Asset 18: Medhurst Crescent Swale

Asset 19: Plimsoll Drive Swale

Figure 9: Poorly established plants to the swale base in the upper length of swale

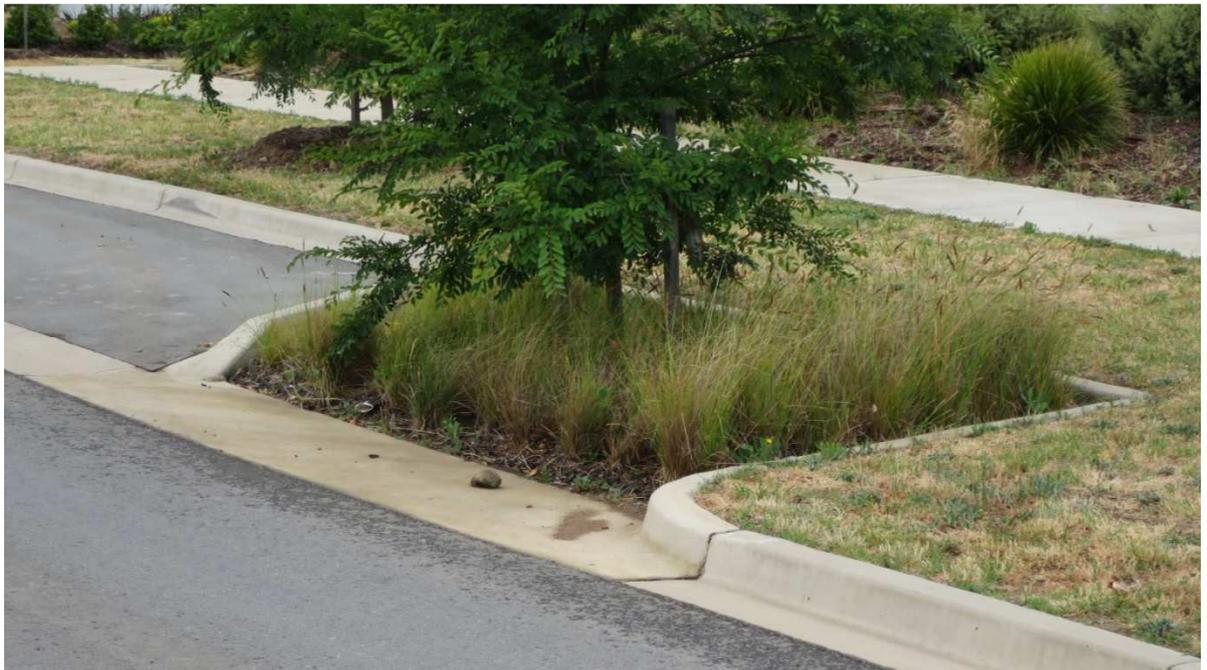
In general the vegetation is performing well (refer Figure 8), but there are some locations at the upstream end of the swale where it has not established well (Figure 9).

Figure 12: Typical swale section from the civil drawing set (4555-70-021)

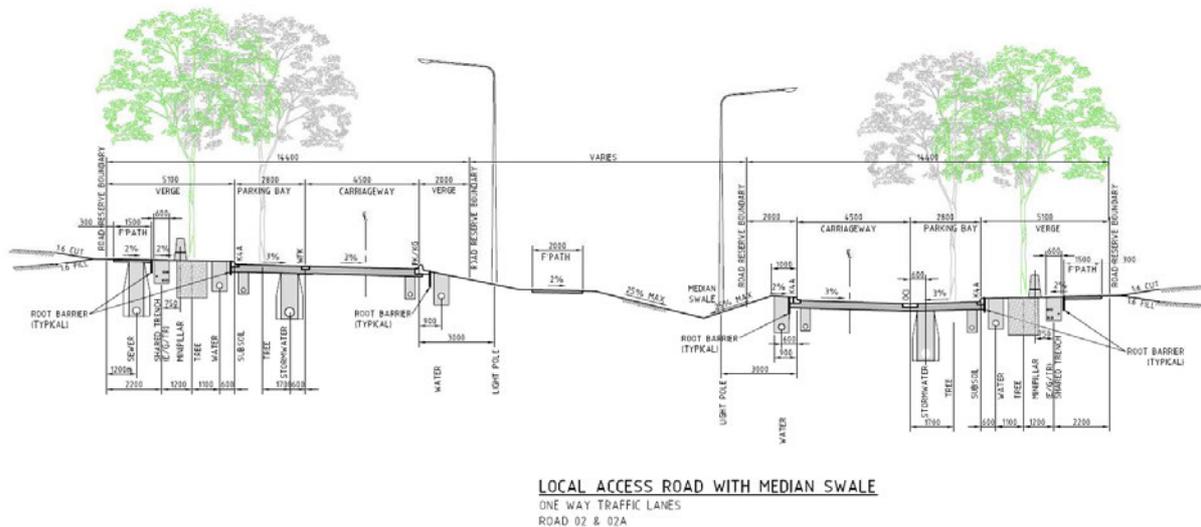
The depth of the swale means that there is a significant drop from the roadway to the swale invert. This significant drop and the resulting steep slope has been the key causal factor leading to erosion. Steep drops like this are subject to erosion if not properly designed with appropriate scour protection. If the swale is only to treat the roadway then it may not have been necessary to construct the swale so deep below the roadway, however the swale is also a major feature of the streetscape providing a green corridor. It may be that the swale was constructed to the depth for landscaping reasons.

It appears that the original design intent was for the swale to have a continuous drop from the roadway to the swale invert, which would have helped to distribute flows along the length of the swale, minimising scour and erosion. However the constructed levels are such that the high point is not the road edge – there is a high point approximately 2 m from the road edge within the swale. This has led to concentration of flows which have forged a path down into the swale at the lowest point in each section.

Therefore the problems appear to have arisen in part at the construction stage, however the design drawings also indicate that the design was not developed well enough to demonstrate how the swale would work, and there is an inadequate level of detail on the drawings to provide appropriate instruction to the contractor. Civil drawings show some very basic swale sections (typical example shown in Figure 12) with the only detail on swale levels being a maximum slope of 25%. Landscape drawings show surface finishes and planting, but no levels in the swale. With this gap in the documentation, it is not surprising that there have been issues at the construction and establishment stages.

- The swale could be improved by allowing the flows from the kerbside drainage channel to pass through to the swale invert in a more dispersed manner, rather than concentrating flows in selected locations. This would require removal of some of the plants and the 'bund' that is preventing flows from passing directly down to the swale invert.

- Turf could be utilised in more parts of the swale. The upper banks of the swale could be re-profiled and revegetated with turf to distribute flows better and provide a stable slope, as well as providing treatment of these flows before they reach the swale invert.

- Instead of trying to direct flows from the road to the swale invert overland, pipes could be retrofitted to deliver low flows to the swale and take up the drop from the roadway to the swale. Pipe outlets should deliver flows well upstream of any stormwater outlet pits so that water has ample contact time with vegetation before it is discharged into the stormwater system.

- Where the swale invert itself is too steep and has been lined with rock, it could be regraded to include flatter vegetated sections and drop structures to take up the grade. This would provide significantly improved treatment performance over a fully rock-lined swale, and can be designed to be stable under a range of flows.

Figure 1: Swale aerial photo 29 October 2014 (NearMap)

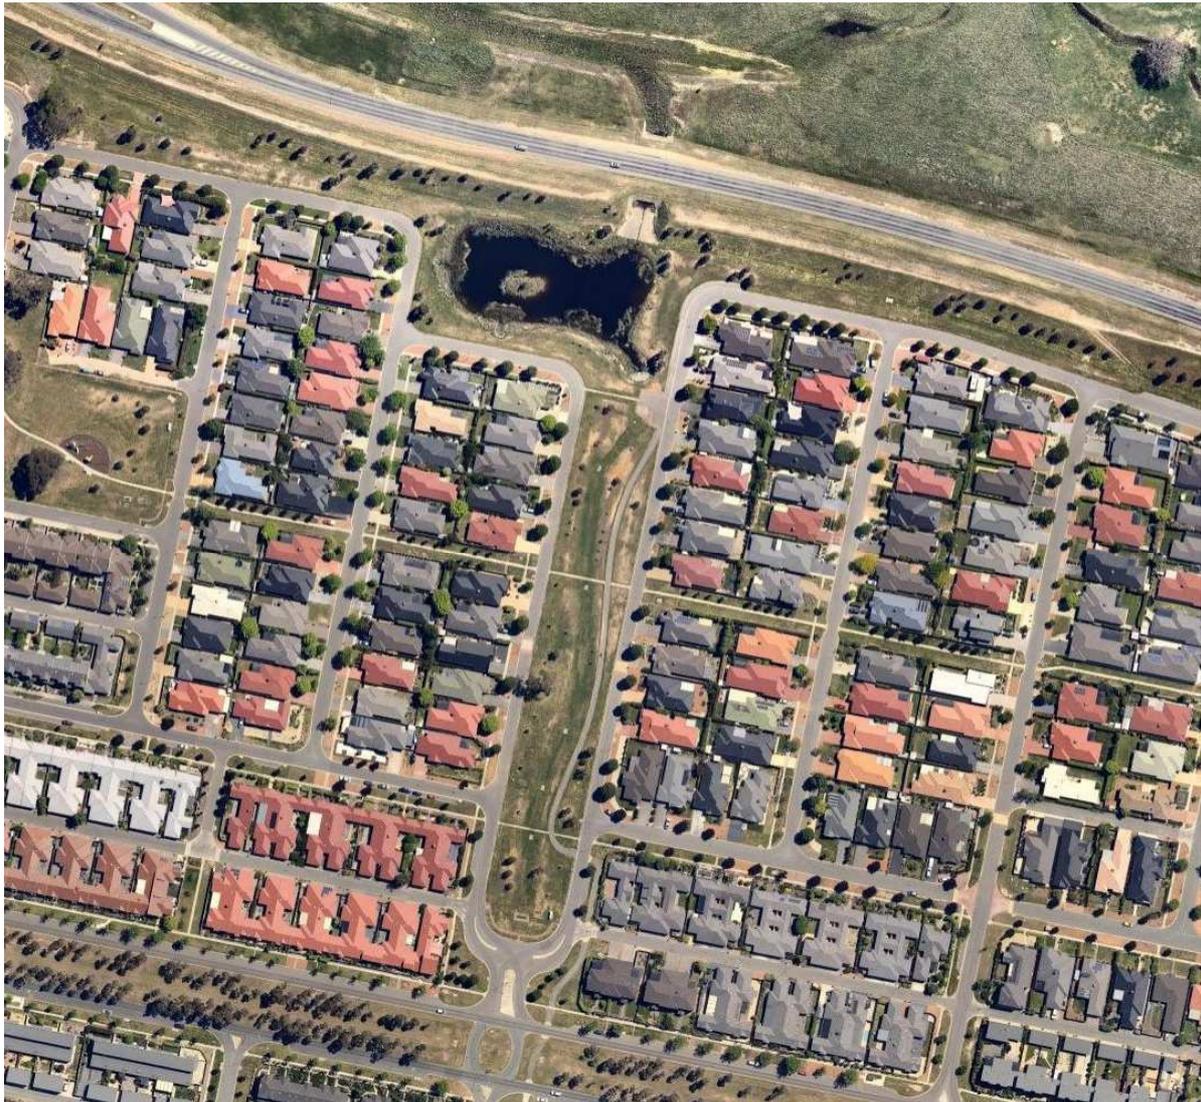
The Tsoulias Street swale is designed to treat stormwater from the roadway catchment areas to the east and west of the swale and any runoff from the turfed areas adjacent to the swale. It also appears that high flows surcharge into the swale however this is a conveyance role rather than a treatment role.

Figure 2: Floating weed cover in November 2010 (NearMap)

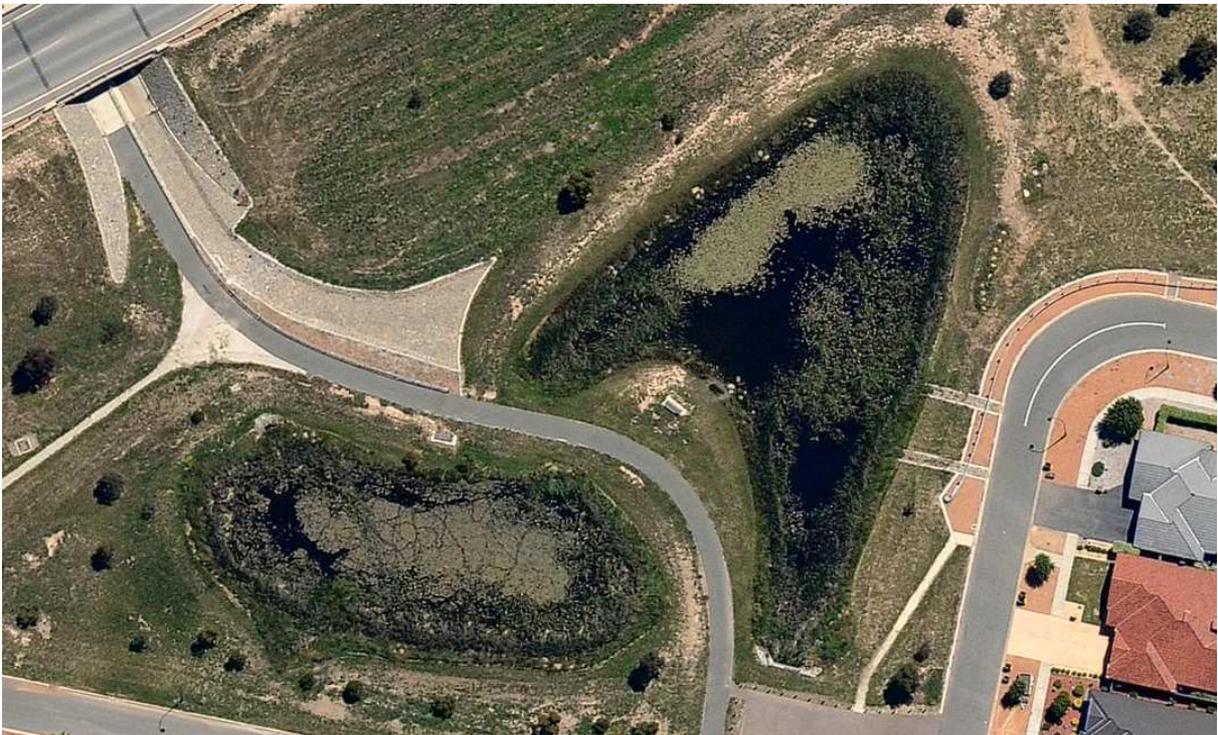
The pond is probably functioning as it was designed, however a key question remains over whether the pond was intended to be an open water system or a macrophyte wetland. It is unclear whether macrophytes were planted or whether *Typha* has colonised the system after construction. Aerial photography from 2009 and 2012 (ACTmapi) and 2010 to 2014 (NearMap) suggests that the macrophyte cover has fluctuated over time, but has generally been increasing over these years. It is possible that macrophyte coverage has increased as sediment has accumulated in the pond. As sediment has accumulated and water depths have reduced, this would have allowed macrophytes to colonise a greater area of the pond, beyond its edges.

- A high flow bypass would protect the system from high flows and improve the treatment performance overall
- Shallower water depths would allow a greater diversity of macrophytes to be planted and established
- A modified bathymetry should encourage better flow distribution throughout the system
- The outlet should be redesigned for a notional detention time of approximately 72 hours, and a greater depth of extended detention would allow more stormwater runoff to be retained for longer in the system
- Consider potential options to improve future sediment management – e.g. a dedicated sediment pond upstream of the macrophyte zone

Figure 1: Sediment accumulation in front of the main inlet to Pond A

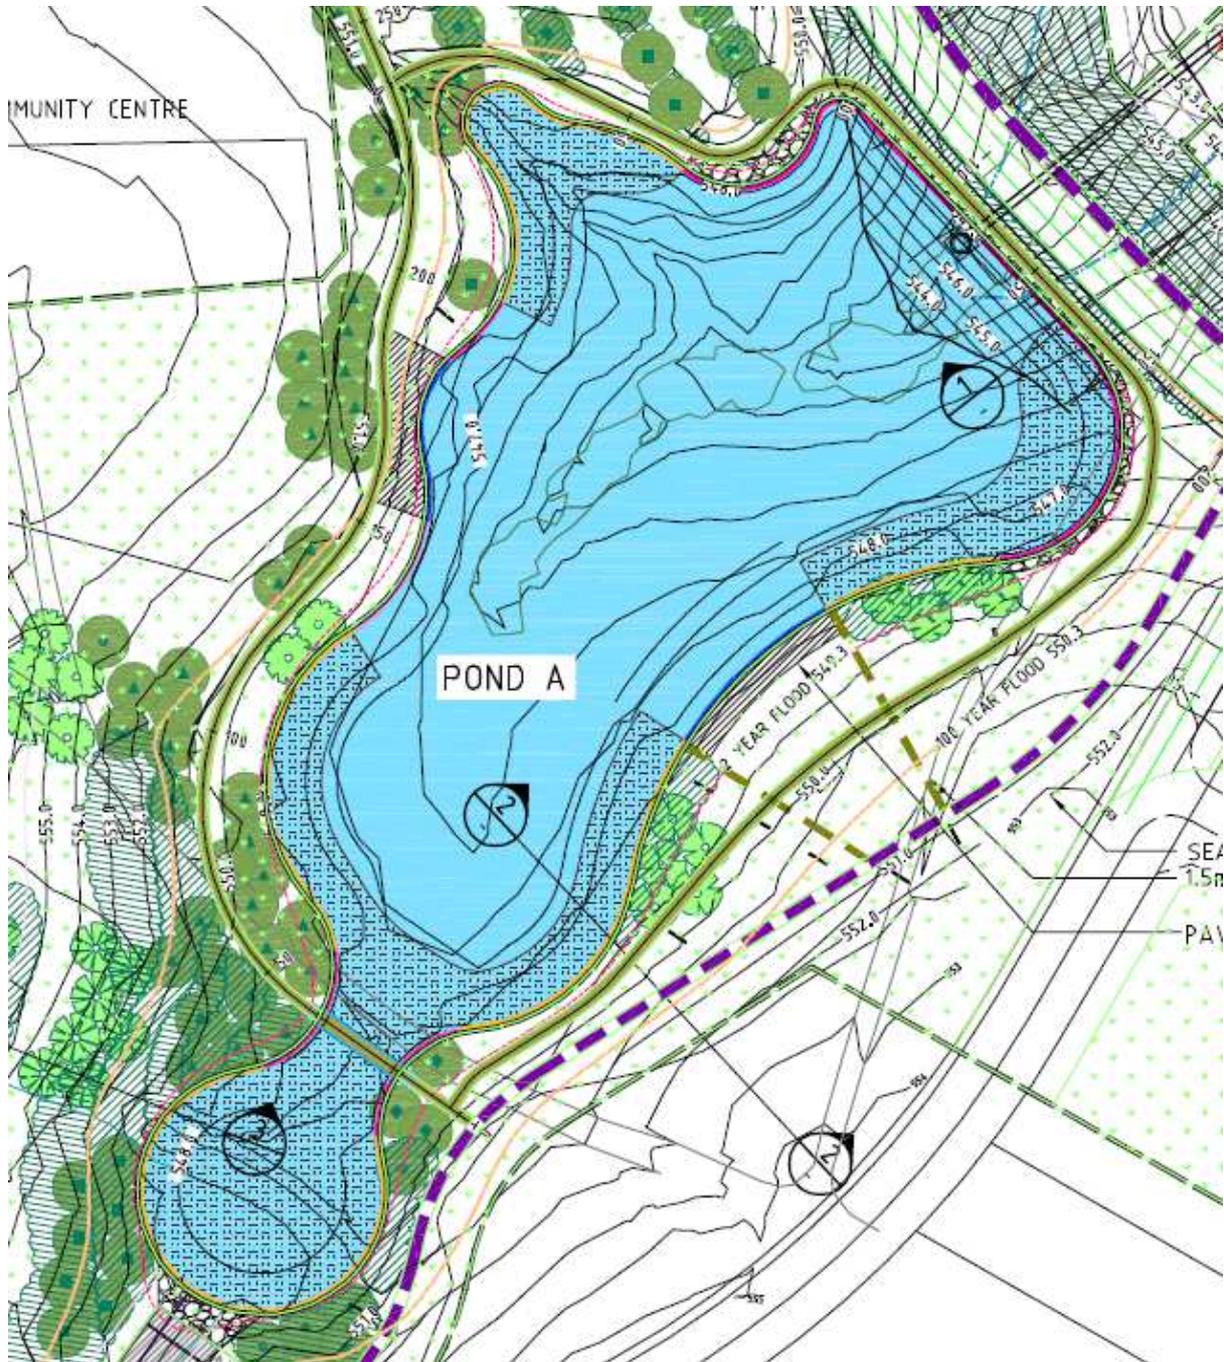
Figure 1 shows the sediment accumulating at the main inlet into Pond A.

It is too early to assess the pond's long-term water quality performance, however our review indicates that, sediment issues aside, there are some inherent design limitations which would limit the treatment effectiveness of the system:

- Assess the feasibility of re-designing the inlet area to be a stand-alone sediment basin upstream of the pond
- A riser outlet and extended detention would allow more stormwater runoff to be retained for longer in the system
- A modified outlet could also allow better water level control in the upper zone, which would assist with macrophyte re-establishment
- More macrophytes would improve the pond's water quality performance

Figure 2: Snapshot from the landscape master plan for Pond B, showing proposed macrophyte area (hatched)

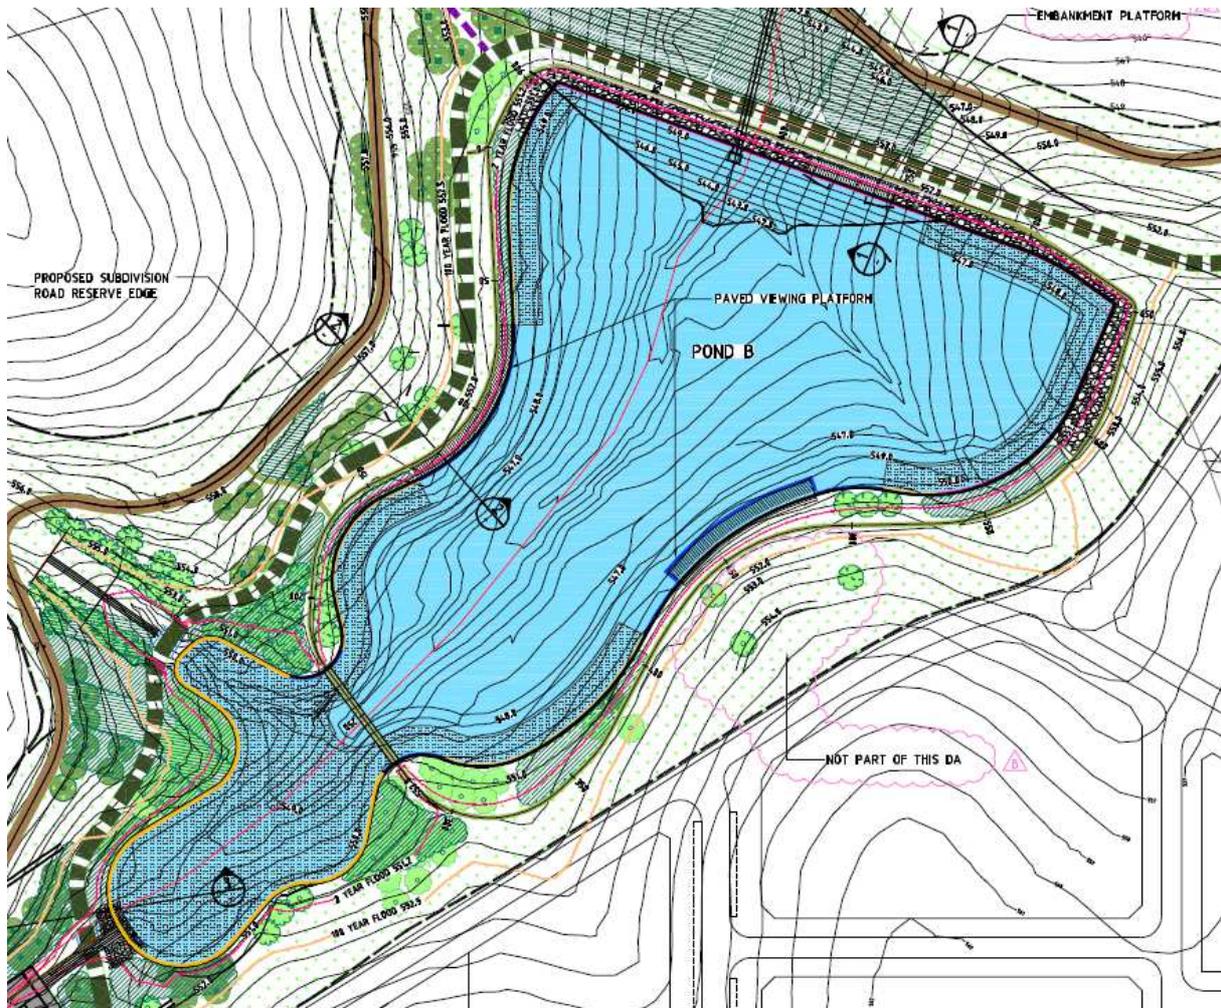
- There is very limited macrophyte coverage (although we note that the design drawings included a more significant extent of macrophyte planting, which has not been established – refer to Figure 2. Analysis of Nearmap aerial photography shows that macrophytes were planted in the pond but failed to establish – it appears that water levels were raised too quickly over small establishing seedlings – refer to Figure 3, Figure 4 and Figure 5)
- The pond is deep and therefore at risk of thermal stratification, which tends to exacerbate water quality issues associated with anaerobic decomposition and re-release of pollutants from accumulated settled sediments

- Assess the feasibility of re-designing the inlet area to be a stand-alone sediment basin upstream of the pond
- A riser outlet and extended detention would allow more stormwater runoff to be retained for longer in the system
- A modified outlet could also allow better water level control in the upper zone, which would assist with macrophyte re-establishment
- More macrophytes would improve the pond's water quality performance
